Ltr pursuant to Para 50.59 of 10CFR50,
Request Change to Tech Specs (App A)
for License DPR-17 w/attached Figures
1 thru 7 for Nine Mile Island...

RE: Docket No. 50-220; License DPR-17

Pursuant to Paragraph 50.59 of 10 CFR Part 50, Niagara Mohawk Power Corporation proposes changes to Appendix A (Technical Specifications) of Provisional Operating License DPR-17 for the Nine Mile Point Nuclear Station.

SCRAM REACTIVITY CURVES

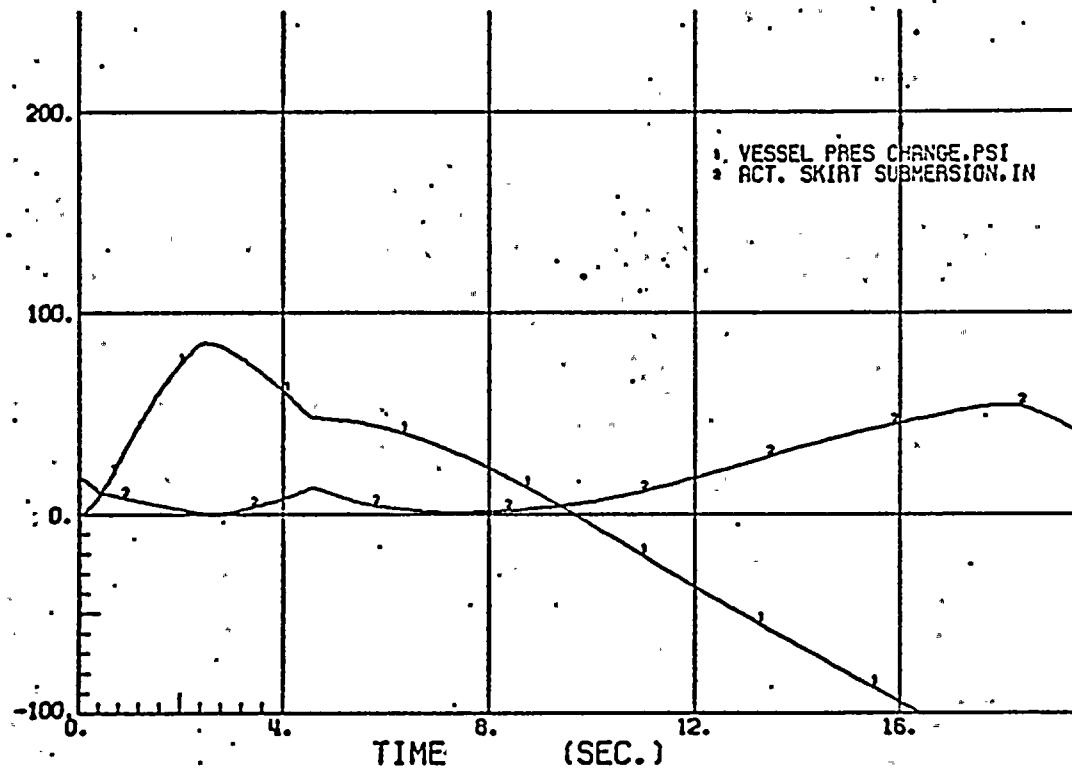
Improved analytical techniques now available at General Electric Company have caused us to adopt a revised basic scram reactivity curve for the calculation of plant response to operational transients. Figure 1 shows the change from the curve previously used by General Electric. This change may occur as the equilibrium fuel cycle is approached.

FIGURE 2

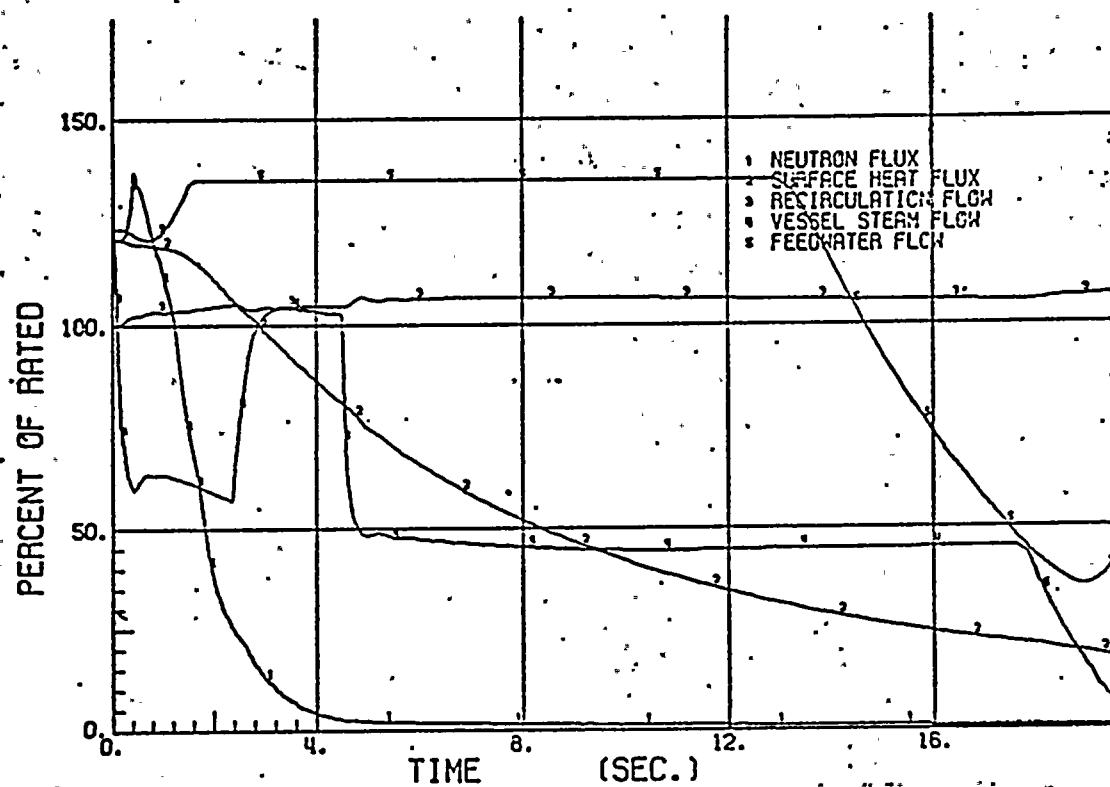
Figure 2 shows a turbine trip with partial bypass at the design rating power level (1850 MWT). The sudden closure of the turbine stop valves causes a trip scram to occur within 10 milliseconds. Neutron flux peaks at about 112 percent of the initial power level at about 0.48 seconds. The core average surface heat flux does not rise above its initial value because of the fast action of the trip scram.

Vessel dome pressure peaks at about 1116 psig while the mid-core peak is about 1131 psig. These are essentially the same pressure peaks that result from a generator trip transient. Vessel pressure exceeds the 1080 psig trip point of the emergency cooling system at about 1.3 seconds, indicating that the design 10 second time delay for actuation is adequate.

Full bypass flow is achieved within 0.3 seconds. The valves remain open until about 18 seconds when the pressure regulator demand becomes less than the combined valve capacity.

Pressure exceeds the 1090 psig set point of the solenoid-actuated relief valves at about 1.6 seconds and the valves remain open for 2.5 seconds.

FIGURE 3
TURBINE TRIP-FAILURE OF BYPASS

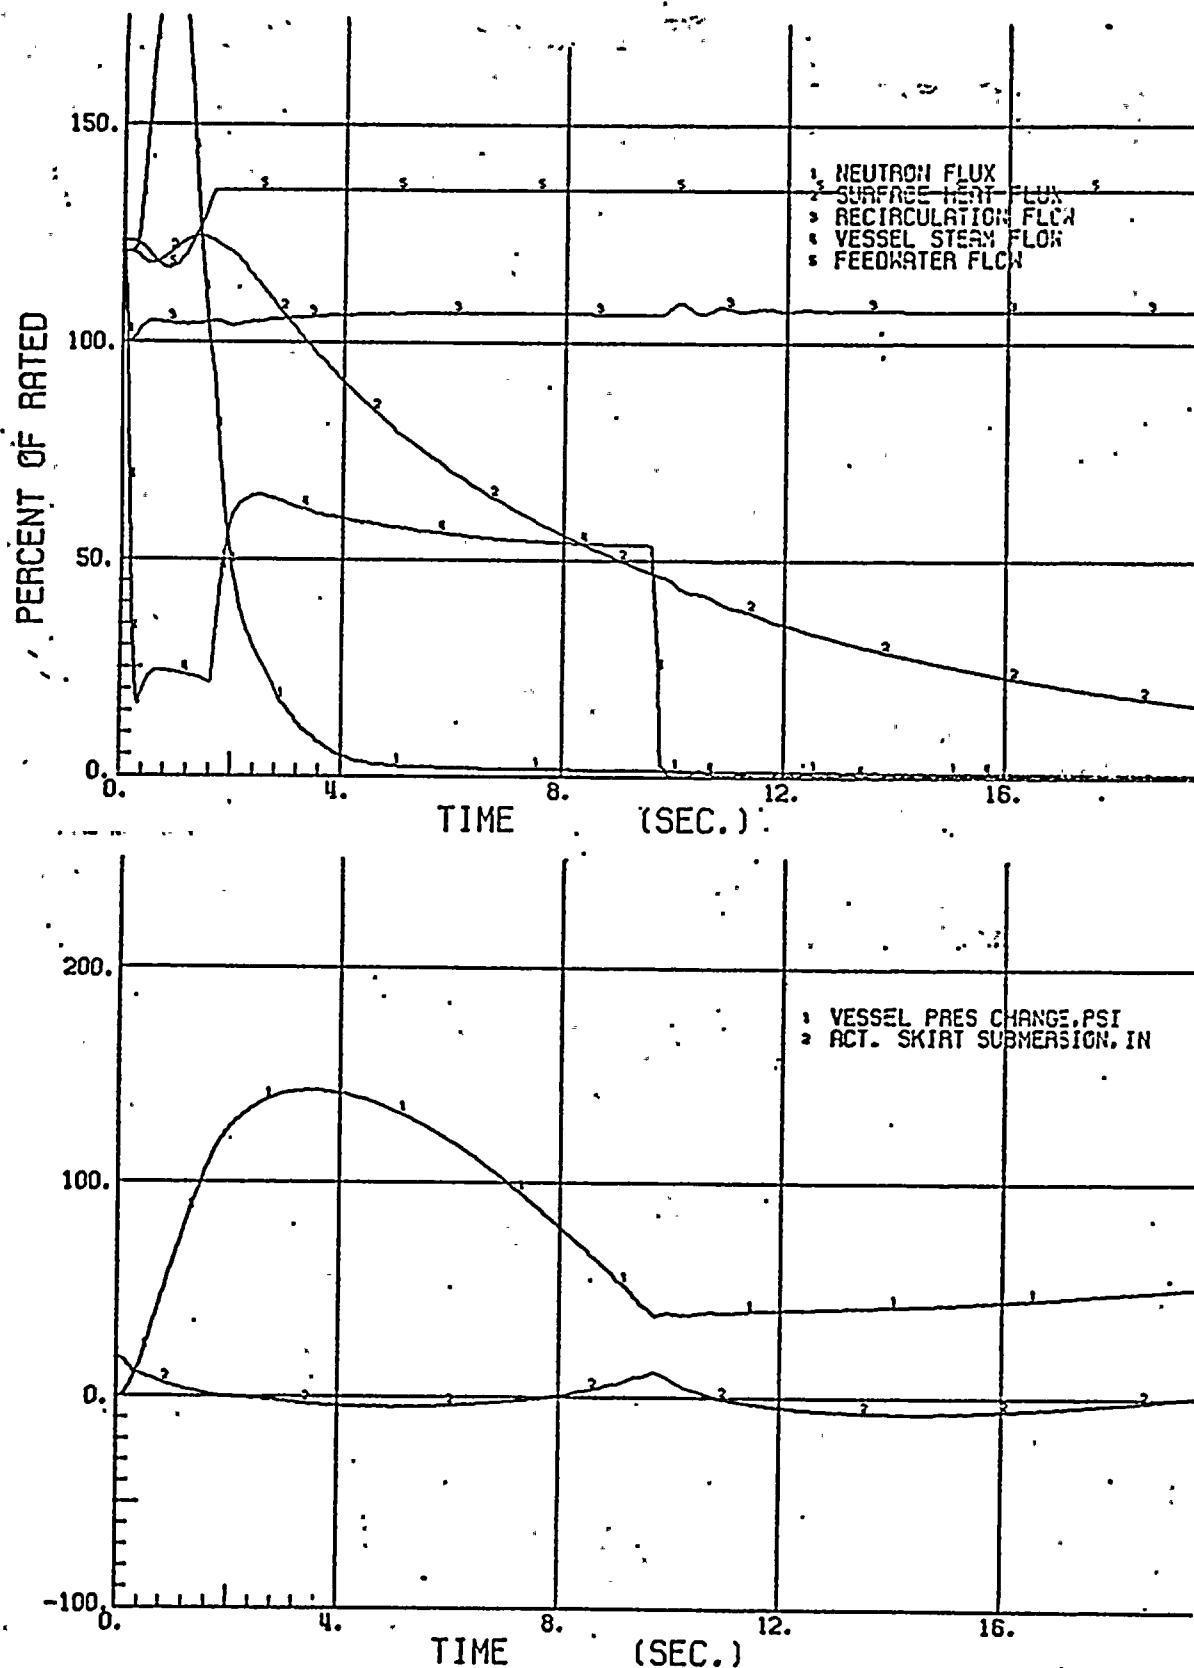
Figure 3 shows the transient resulting from the closure of the turbine stop valves with simultaneous failure of the bypass system. This accident causes a trip scram to occur within 10 milliseconds. Neutron flux peaks at about 163 percent of initial value at about 0.85 seconds. Because of the trip scram action, the core surface heat flux remains below the initial value. The relief valves open at about 1.6 seconds and then remain open for about 9 seconds. Trip scram and the solenoid-actuated relief valve operation turn the pressure transient and drop reactor power and pressure to levels at which the emergency cooling system can accommodate the remaining reactor decay heat.

The analysis indicates that the pressure peak at the location of the safety valves is approximately 44 psi below the set point of the first group of safety valves.

Pressure in the vessel dome peaks at 1174 psig and the mid-core pressure peaks at 1185 psig which is well below the fuel design pressure limits.

The solenoid actuated relief valves set point has been lowered to maintain the margin to the first safety valve set point.

FIGURE 4
MAIN STEAM ISOLATION VALVE
CLOSURE

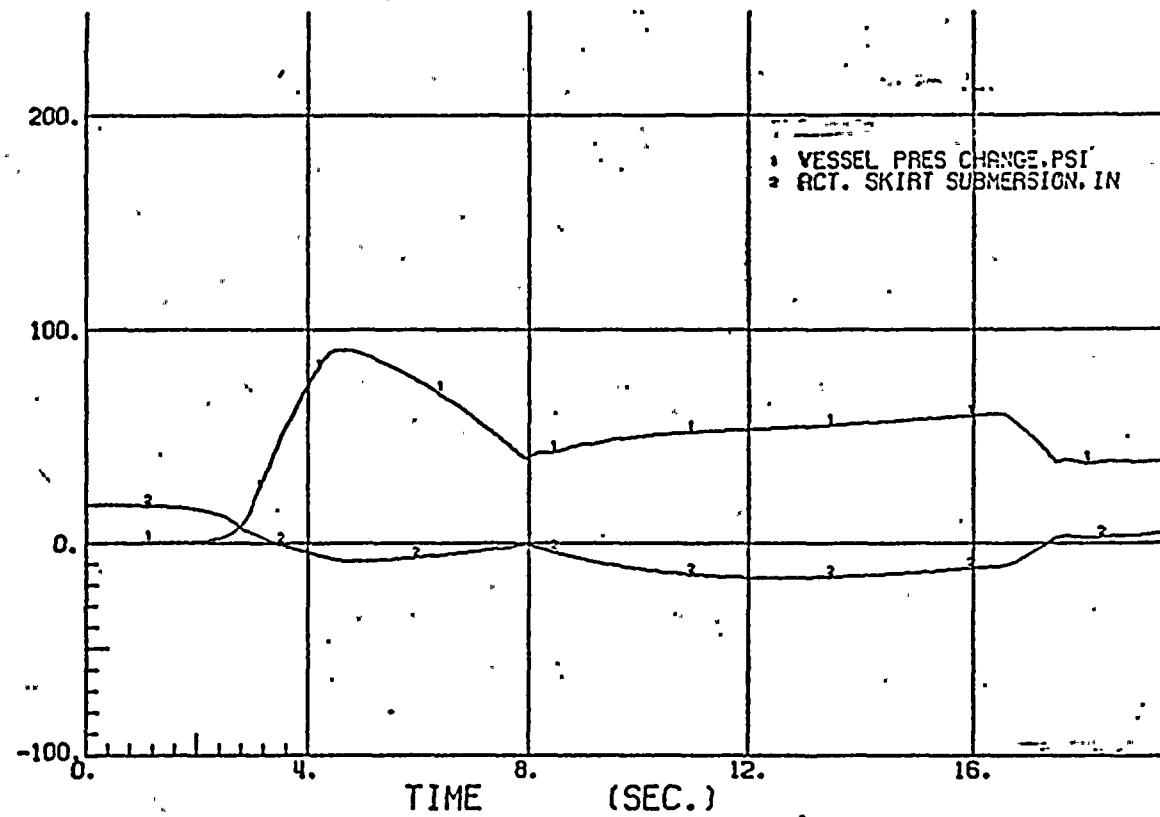
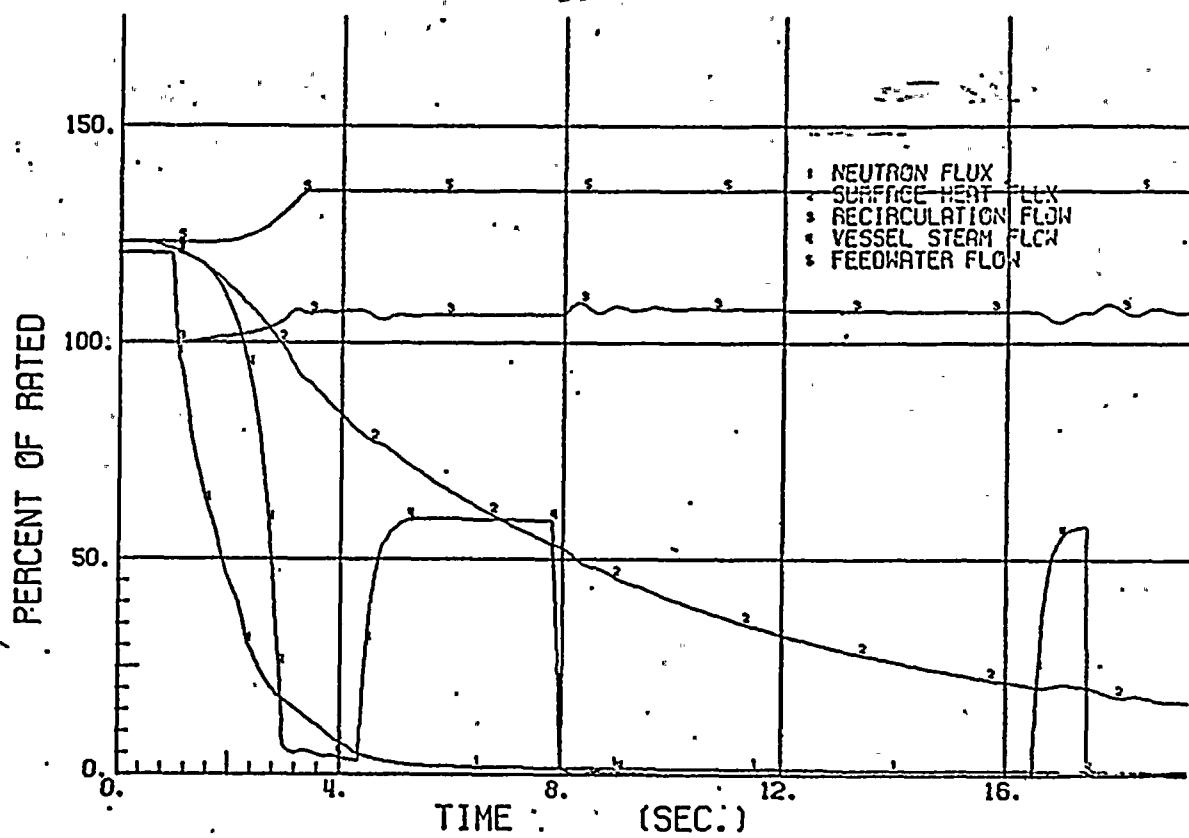
Figure 4 shows the transients resulting from a three-second main steam line valve closure. It is apparent that at the 1850 MWT power level the solenoid-actuated relief valves remain adequate to prevent lifting of the safety valves.

The pressure at the location of the relief valves reaches the set point value of 1090 psig at about 3.7 seconds. The opening of the valves holds the vessel dome pressure peak to about 1121 psig which is well below the first safety valve set point. Mid-core pressure peaks at about 1135 psig.

FIGURE 5
FEEDWATER CONTROLLER MALFUNCTION
(INCREASE FLOW)

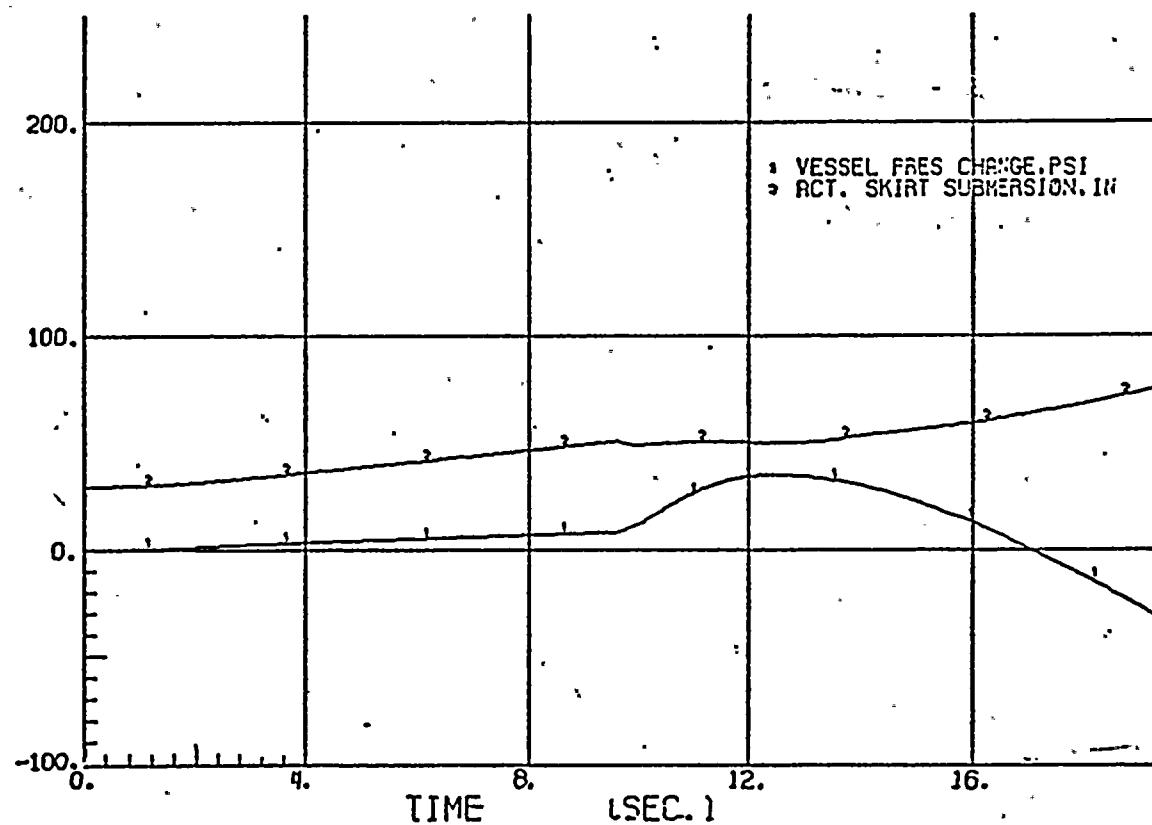
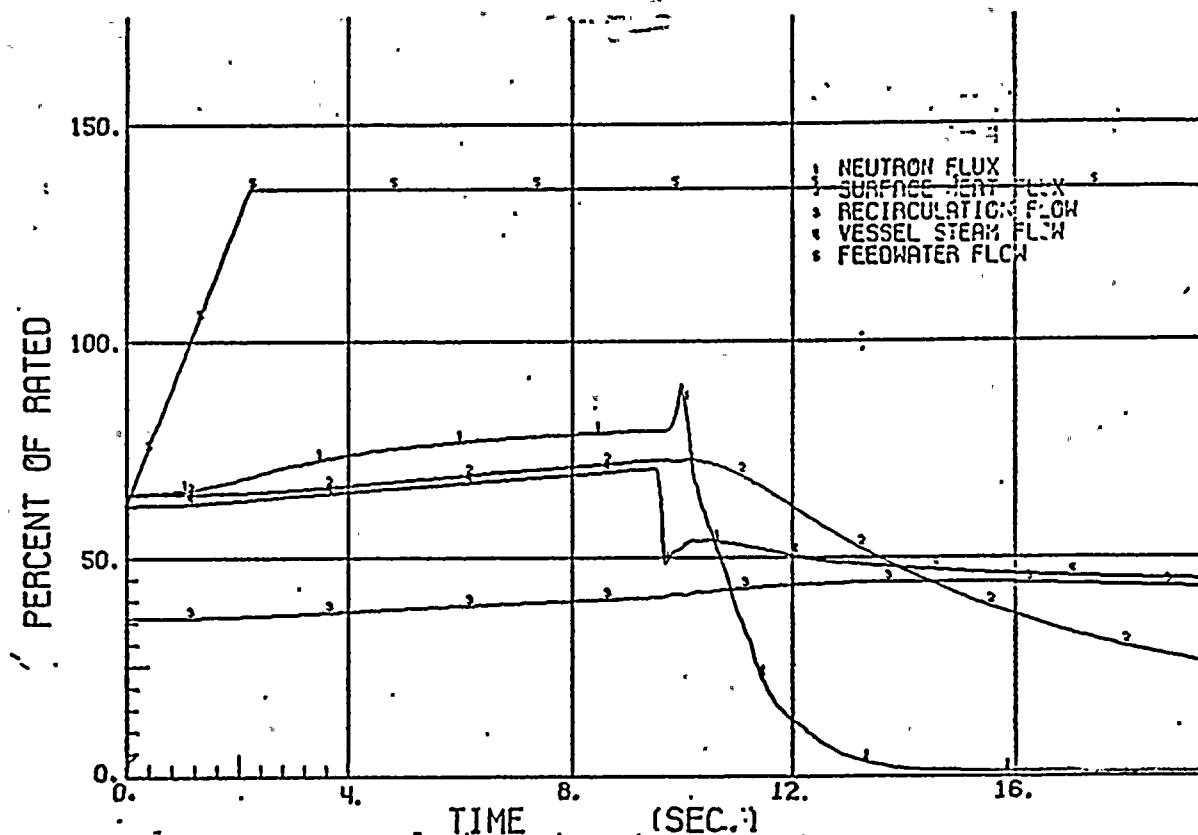
Figure 5 shows the transient of a feedwater controller failing open. The transient is brought under control by the high water level turbine trip.

The transient is initiated with reactor power at about 54 percent of the 1850 MWT power level and about 35 percent of recirculation flow. Because of the mismatch between steam flow and feedwater flow, the vessel water level begins to rise and climbs at a maximum rate of about 3 inches per second after the maximum feedwater rate is achieved.

The high water level turbine trip is initiated at about 9.6 seconds. At the same time trip scram is also initiated. Neutron flux peaks at 90 percent of the 1850 MWT level at about 10 seconds and the core average surface heat flux peaks at about 61 percent shortly thereafter. Recirculation flow at this time is about 41.5 percent. The critical heat flux ratio at all times is greater than that at full power.

The pressure rise continues for a short time after the scram is initiated with the pressure peak occurring at about 12 seconds after the feedwater controller malfunction. The analysis indicates that peak pressure at mid-core is about 996 psig and about 992 psig in the vessel dome.

FIGURE 6
LOSS OF AUXILIARY POWER

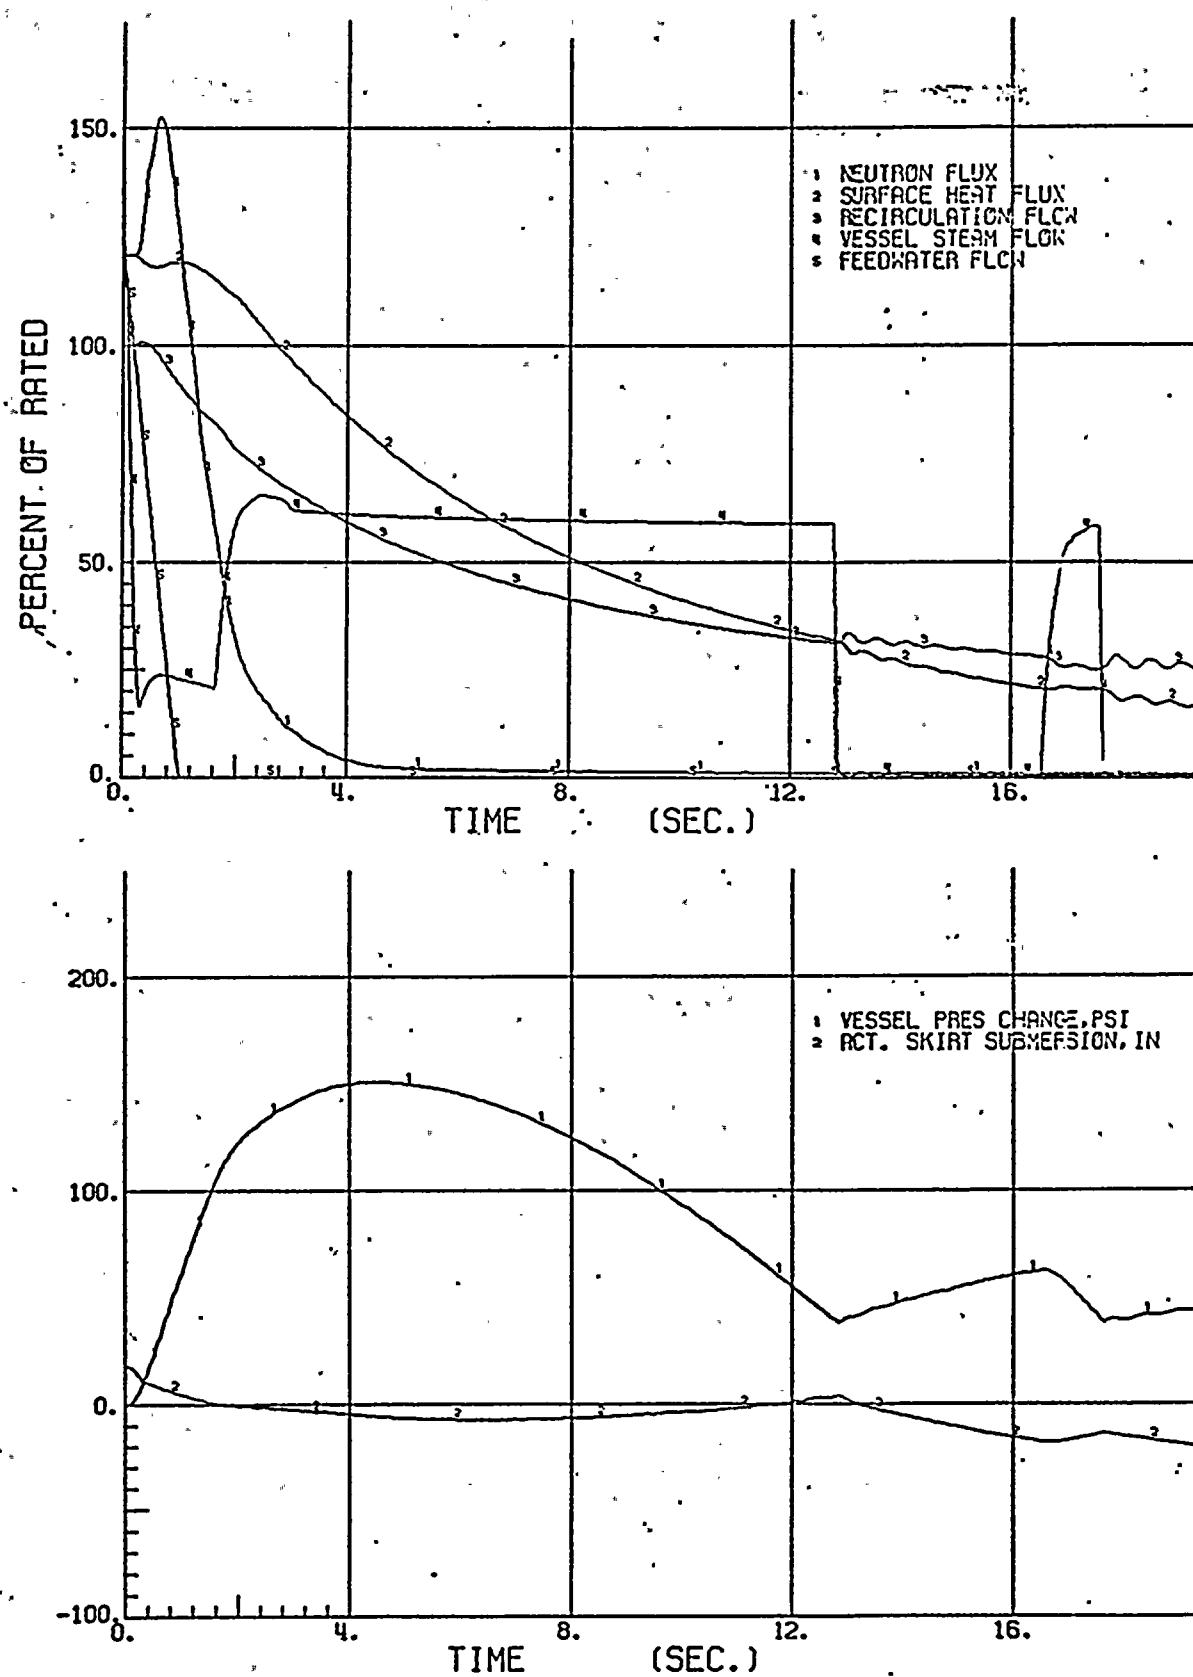
Figure 6 shows the results of the transient. Neutron flux peaks at 156.7 percent of the initial value at about 0.7 seconds. The relief valves open in about 1.6 seconds. Full flow capacity is achieved at 2.1 seconds later. The relief valves continue to function until about 12.6 seconds when the pressure at the location of the valves falls below the set point. However, heat continues to be generated after the relief valves are closed, building up pressure slowly such that the relief valves are again actuated at about 16.5 seconds.

The pressure drops quickly to the set point of the valves and again they close. The relief valves will continue to cycle as shown until heat generation has dropped to the capacity of the emergency cooling system.

Vessel dome pressure peaks at 1181 psig, well below the first set point of the safety valves. Mid-core pressure peaks at about 1187 psig.
